Publication Number: ID0555609

Safety Notice

Affected Models	HX30, HX50, HX75 on VT24 trailers (see attached list for affected VINs)
Attention	Dealership Owners, Managers, Parts and Service Managers
What Dealer Should Do	 Read the attached customer notice. Check safety notification search tool on Dealer Central to see a list of units in your area. Order 2 kits for each affected trailer in your area. Check axles using procedure on following page to see if they are from affected lots. Repair both hubs on each affected axle using instructions provided by Dexter and attached to this safety notification. Submit warranty claim. Reference the lot number on the claim.
Parts Required	1 kit per axle: 500-3425 12K axle bearing kit
Estimated Repair Time	inspection: 30 minutes per machine repair: 2 hr per axle
Compensation	labor and mileage
Dealership Notes	URGENT: Please perform this update as soon as possible in the interest of safety. Ditch Witch requests that you update all machines in your area by 09/30/2019. A notification will be mailed to owners of affected models in two weeks. Please note "What You Should Do" section of the attached customer notice. If you have any questions, contact

Find Lot Number

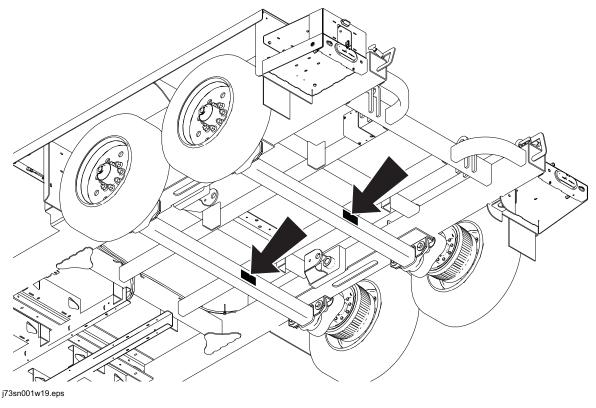
- 1. Block trailer tires.
- 2. From rear of trailer, inspect axle lot number etching on both axles.

IMPORTANT: Front axle requires inspection from under trailer.

3. If the lot is one of the following numbers, replace both hubs using kit 500-3425.
